SCHEMATIC CONDUIT DIAGRAM  
 OVER LEWES & REHOBOTH CANAL  
 SAVANNAH ROAD BRIDGE

SAVANNAH ROAD BRIDGE  
 LEWIS I. DEBEL  
 SCALE: AS LISTED  
 DATE: 1/21/83  
 PASCALE LEAF LIGHTING & POWER  
 TUDOR Z ELEC  
 DRAWING NUMBER  
 OFFICE COPY

HARDESTY & HANOVER  
 CONSULTING ENGINEERS  
 W. B. Burgess  
 MAY 2, 1983

SAVANNAH BRIDGE  
LEWIS, DEL  
 SCALE AS NOTED  
 DATE 9/2/82  
 APPROVED BY  
 TUDOR ELEC NOV 1982  
 DRAWING NUMBER  
 HANOVER

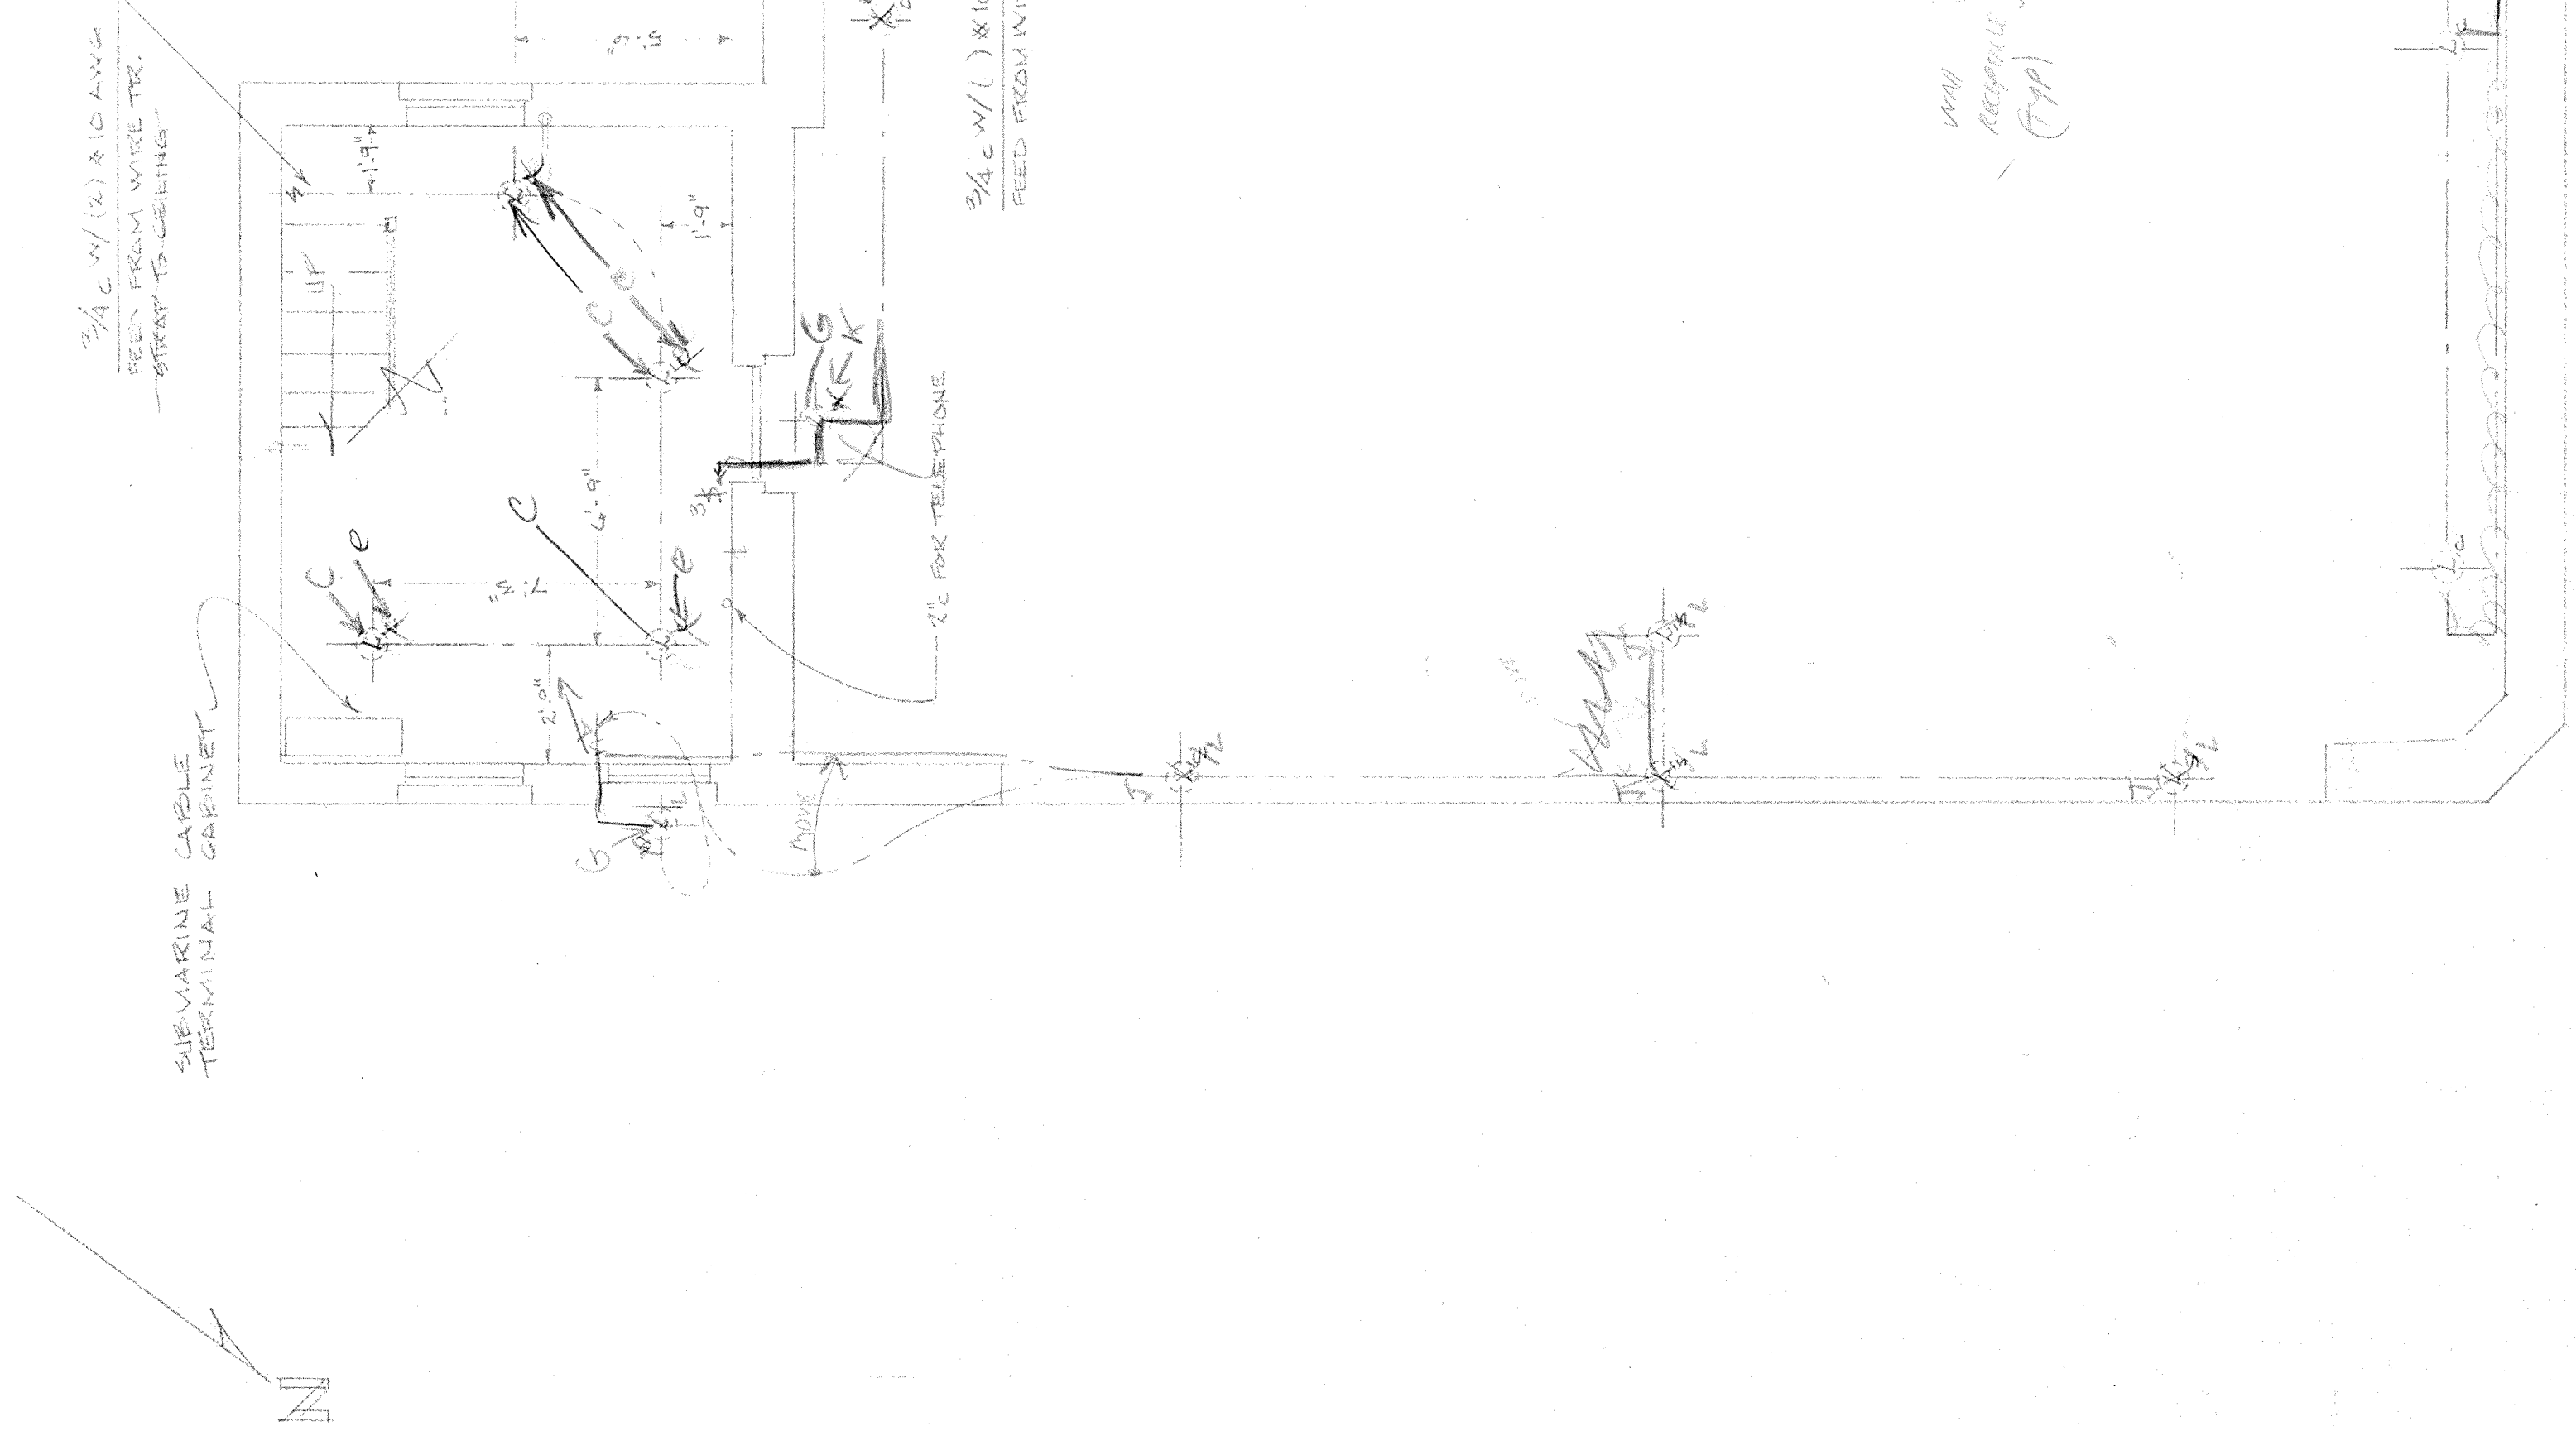
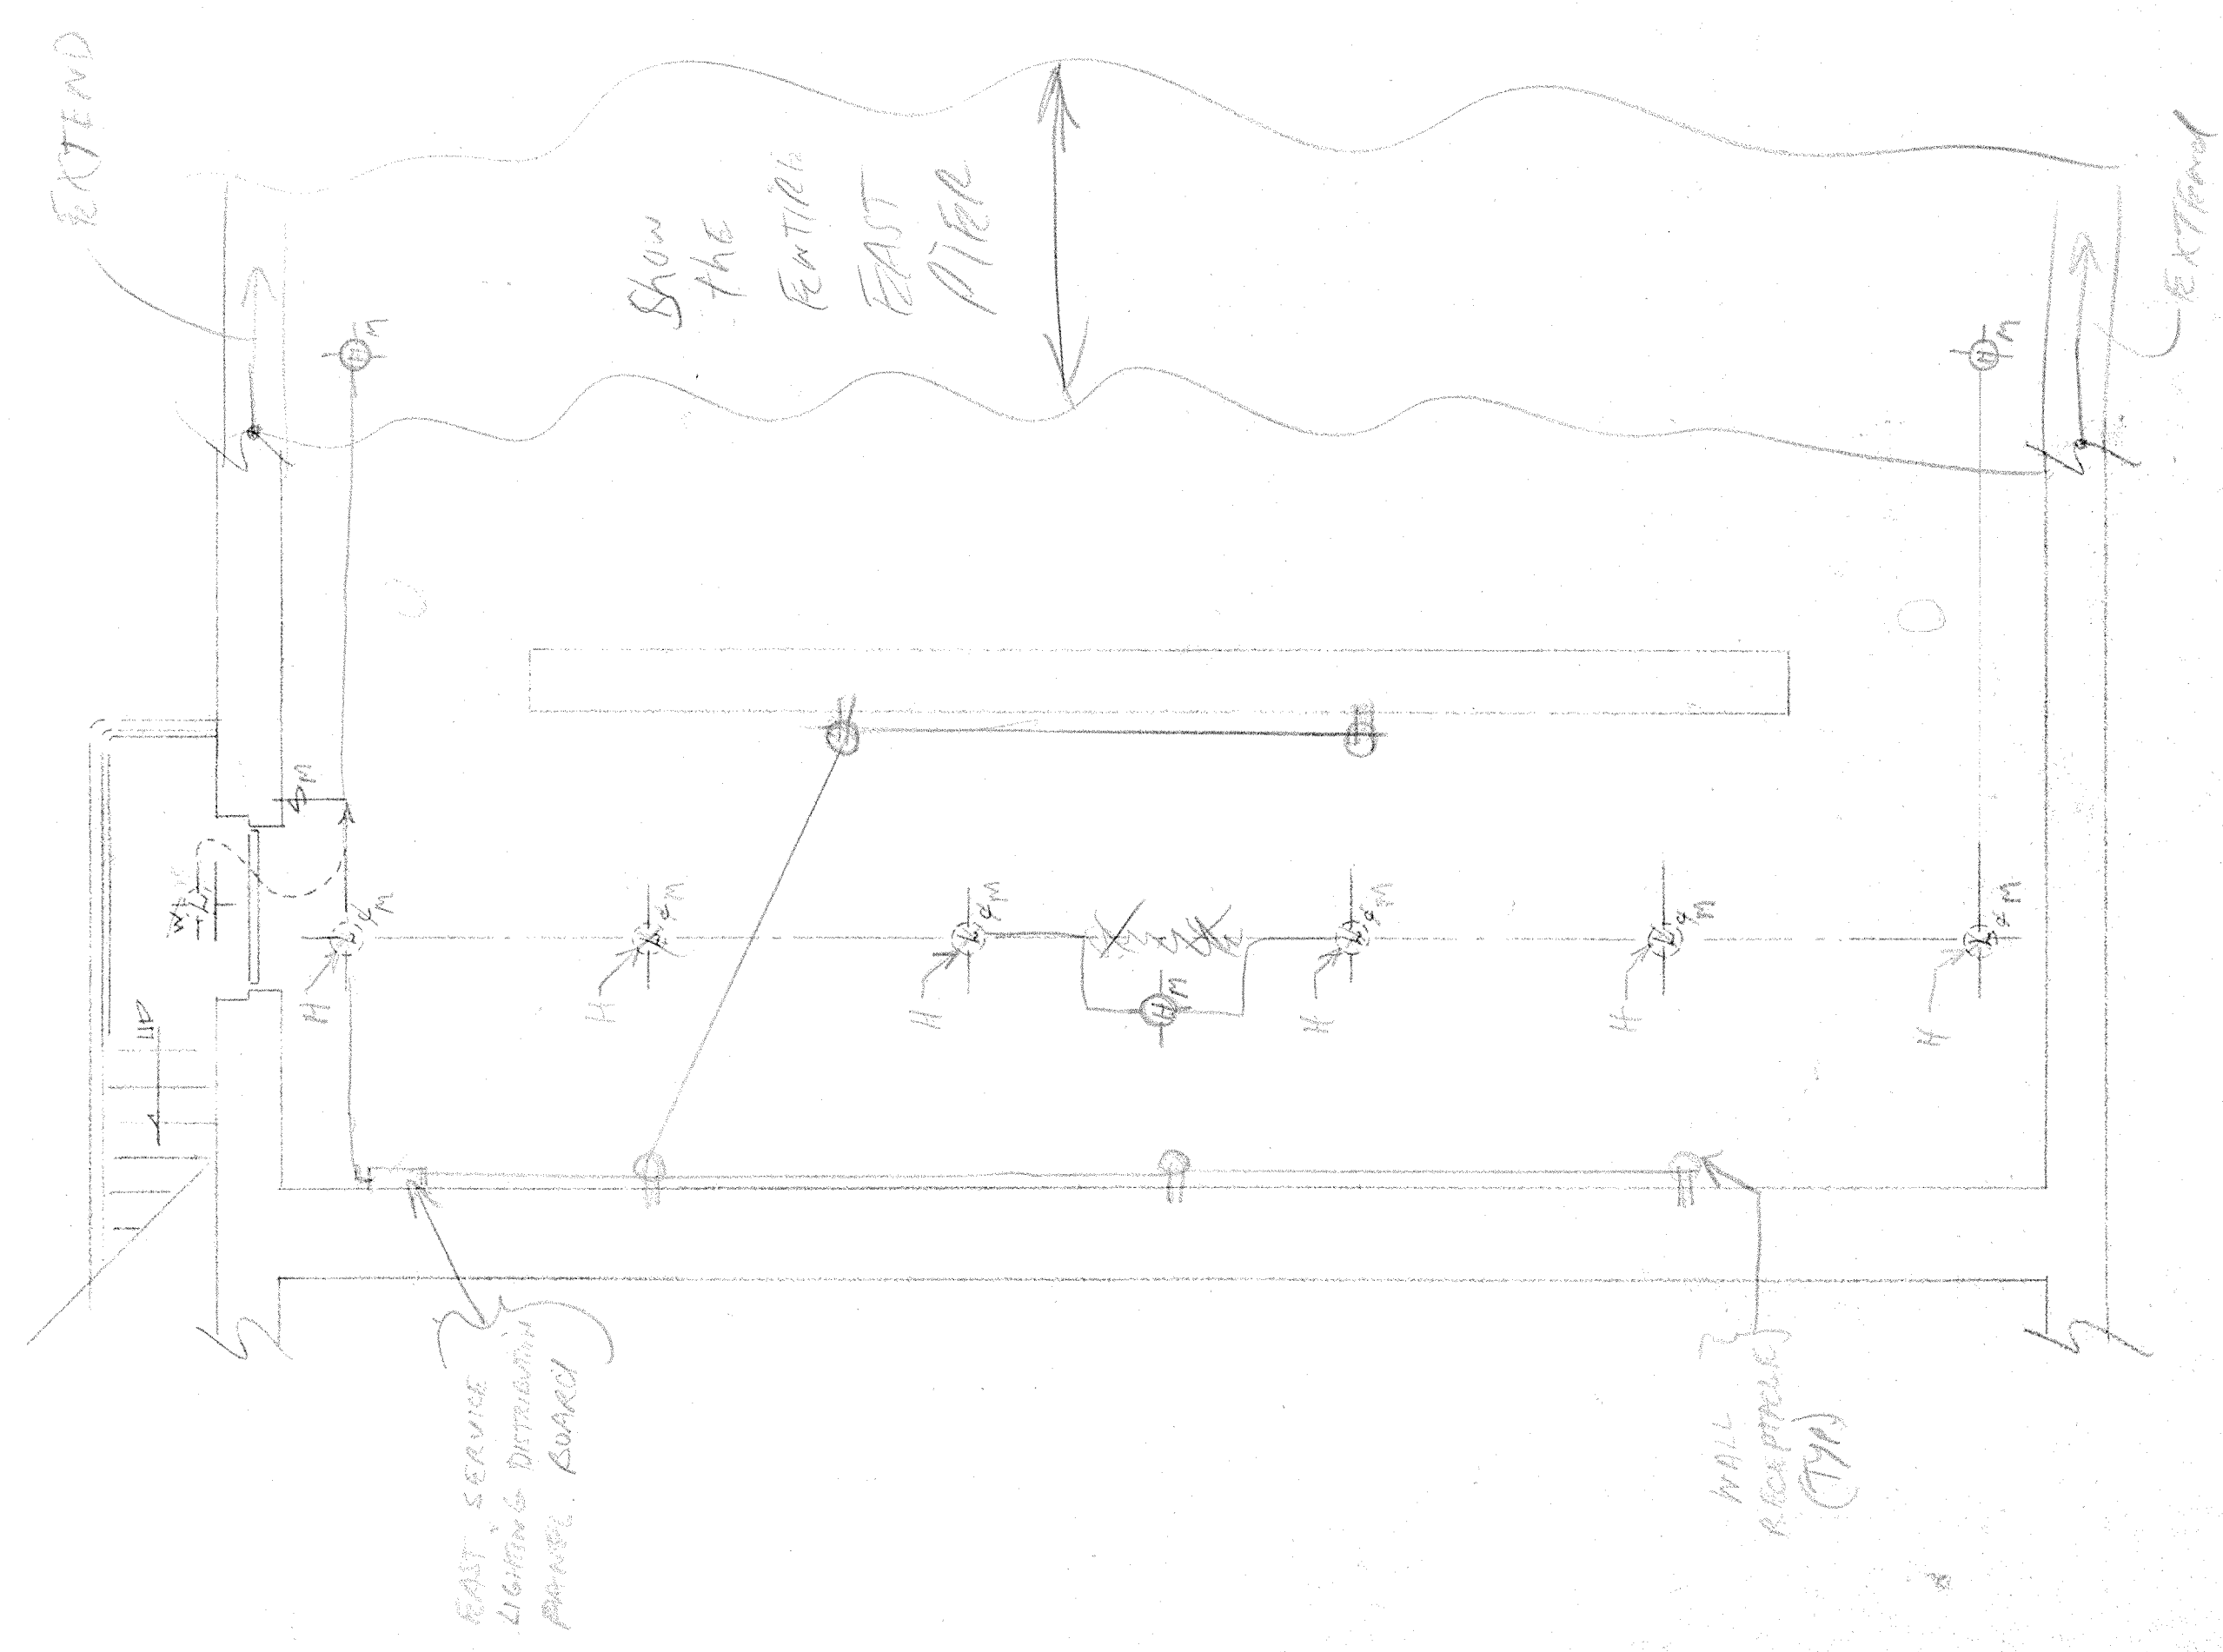
PROVIDE A BETTER NUMBERING SYSTEM FOR THE DRAWING. DMS #3 WAS ALREADY USED FOR THE ROOM DESIGNATION OF THE OPERATORS LAYOUT.
